SI M11 01 17  
Engine

## FAULT 118002 - MIXTURE TOO RICH SETS DURING WINTER WITH COLD AMBIENT TEMPERATURES

This Service Information bulletin supersedes SI M11 01 17 **dated May 2019**.

4. Inspect the version of the cylinder head cover

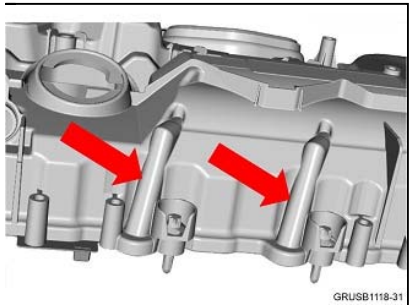
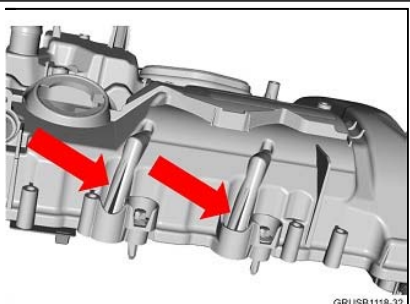
<p style="font-size: 8px; margin-top: 5px;">GRUSB1118-31</p>	<p>The older version is shown to the left.</p>
 <p style="font-size: 8px; margin-top: 5px;">GRUSB1118-32</p>	<p>The newer version is shown to the left                  Note: This updated version can be identified by the additional supports on crankcase ventilation ports</p>

Replace the cylinder head cover and profile gasket if the older version is equipped.
